Subj: G-7 RANGE -- ARTILLERY DIRECT FIRE

Subj: MODIFICATION OF G-7 RANGE

Subj: G-7 RANGE

Firing Point

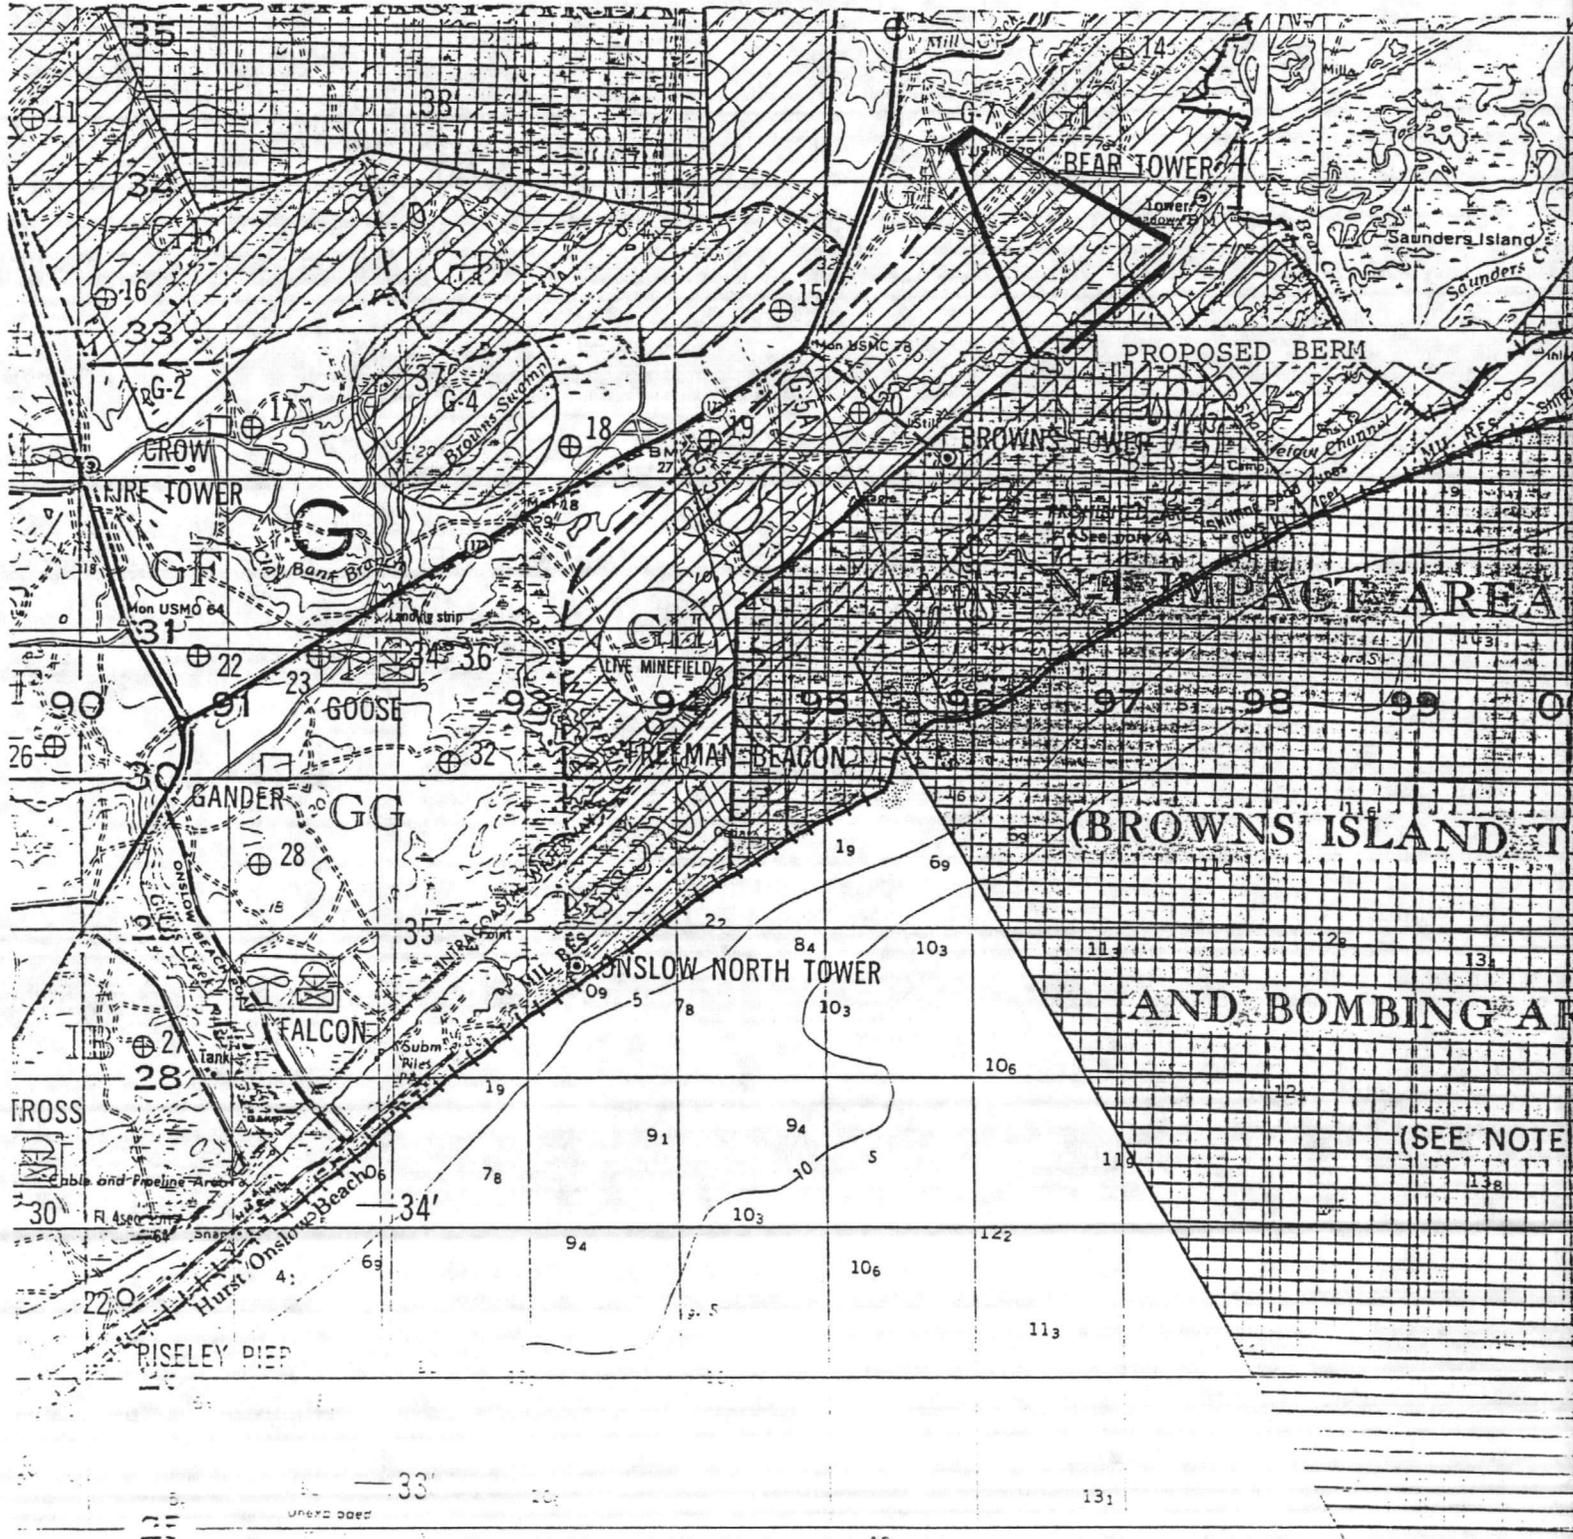
1. It is requested that an additional berm be constructed 950m~~m~~ down range of G-7. This berm should be approximately nine feet high, two hundred feet long and have a road bed width of eleven feet. It is also requested that, after completion, this berm be reseeded to reduce erosion problems.
2. This berm will fill a training gap for 10th Marine Regiment. At the present time there is no available area to direct fire the 203mm projectile. In accordance with reference (a) all 203mm direct fire has taken place using a distance of 3000 meters which is not an excellent example of direct fire.
3. There is no significant environmental impact due to the fact that the berm will be located in the impact area of G-7. See enclosures (1) and (2).
4. Point of contact is 1Lt R.C. GRAHAM, Range Maintenance Officer, extension 3065/3066.

G-7 Direct firing limitations for 203mm howitzers

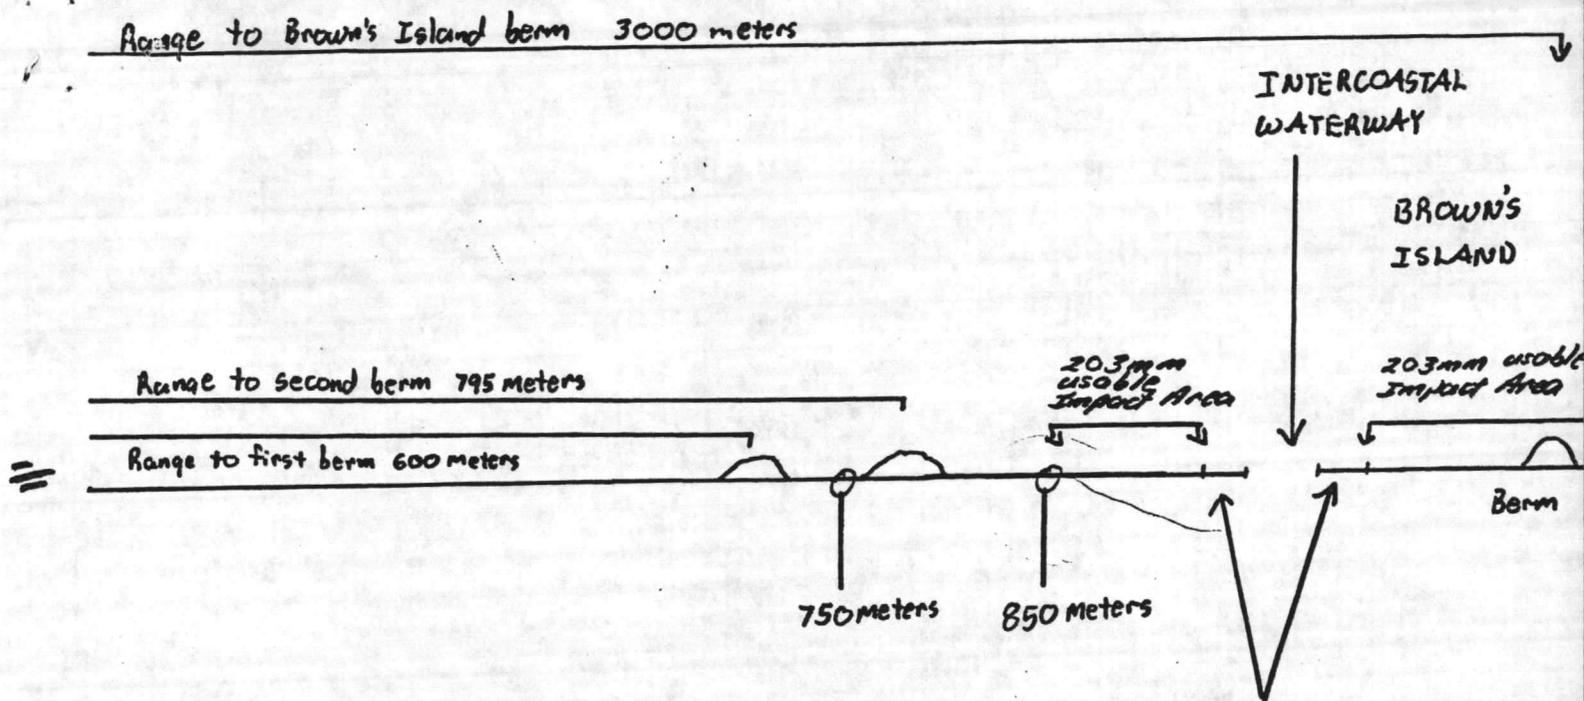
2. The physical layout of the G-7 range coupled with the firing restrictions imposed by the references prohibit safe direct firing of 203mm projectiles on the near side of the intercoastal waterway. Enclosure (1) further depicts these restrictions. The substitute for direct firing is to "lob" projectiles out to a berm on Brown's Island (3000 meters away) which is not an excellent illustration of direct fire.

- b. Construct a berm 900 meters southwest of the G-7 tower so that 203mm projectiles can be fired without ricochet or falling short of a line 850 meters southeast of the G-7 tower. This 850 meter safety line is required by reference (b). The left azimuth limit will need to be adjusted to 2350 mils (130 degrees).

2. After additional coordination between the Range Maintenance Officer and your Safety Officer, the modification described at the enclosure was decided upon. The 300 meter restriction will be changed upon completion of the range modification to accommodate direct fire.
